# 1993 Corvette: Service Bulletin: Transmission "Whine" Noise, Loss of Motion in all Gears, or Missing Clutch Disc Rivets

**Model and Year:** 1993 CHEVROLET CORVETTE WITH SIX-SPEED MANUAL TRANSMISSION AND 5.7L (LT1) ENGINE (VIN CODE P)

**Bulletin Number:** 37-71-40

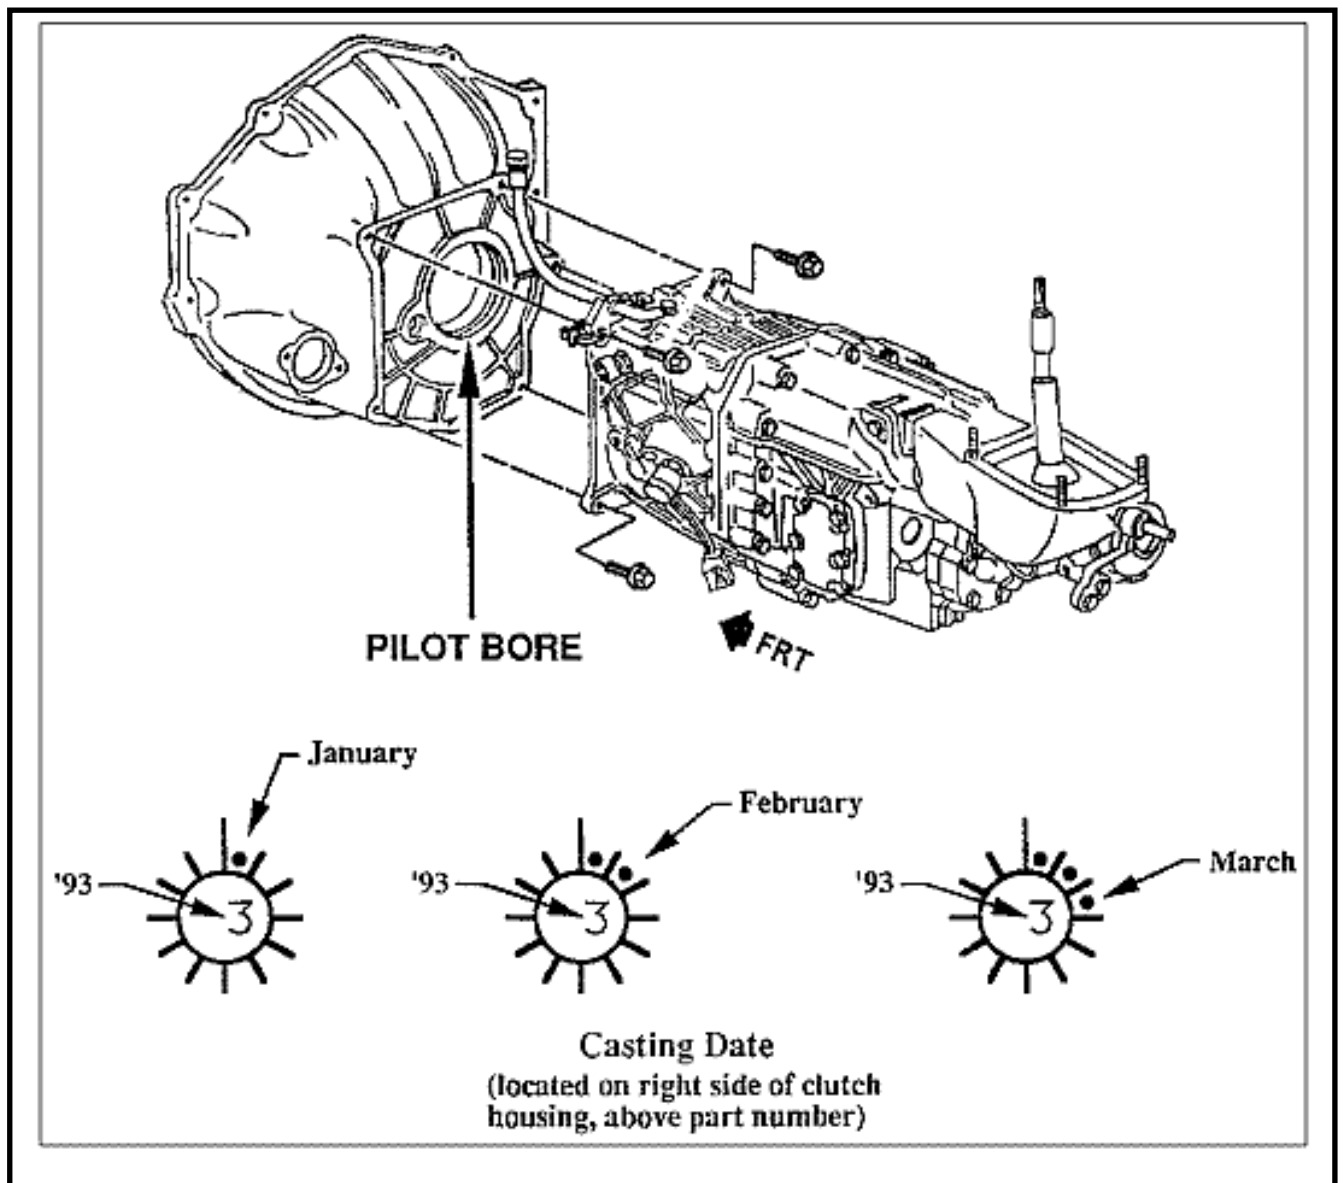
IF THE VEHICLE IS BUILT BETWEEN THE VIN BREAKPOINTS OF 110966 THROUGH 113902 AND THE CLUTCH HOUSING HAS A CASTING DATE OF EITHER "JANUARY, FEBRUARY, OR MARCH 1993", THE CLUTCH HOUSING MAY BE THE CAUSE OF THE CONCERNS. THE CLUTCH HOUSING MAY HAVE A MISLOCATED TRANSMISSION TO CLUTCH HOUSING PILOT BORE. SEE FIGURE.

THIS MISLOCATED PILOT BORE MAY SIDELOAD THE TRANSMISSION'S INPUT SHAFT, THEREBY PRODUCING THE "WHINE" NOISE.

THE ABOVE CONDITION MAY ALSO SHEAR THE RIVETS OF THE CLUTCH DRIVEN DISC CAUSING THE CLUTCH DRIVEN DISC FRICTION FACING TO BE DISENGAGED FROM THE SPLINED HUB.

VERIFY THE SUSPECT CLUTCH HOUSING HAS A CASTING DATE OF EITHER "JANUARY, FEBRUARY, OR MARCH 1993". NOTE: SUSPECT HOUSINGS WILL HAVE NO MORE THAN THREE (3) "DOTS" IN THE CAST DATE. SEE FIGURE.

AFTER ABOVE VERIFICATION, REPLACE CLUTCH HOUSING, P/N 10126448. PARTS ARE CURRENTLY AVAILABLE FROM GMSPO.

NOTE: IF THE VEHICLE REQUIRES A REPLACEMENT OF THE CLUTCH DRIVEN DISC DUE TO SHEARED RIVETS, THE CLUTCH HOUSING \*\* MUST \*\* ALSO BE REPLACED.
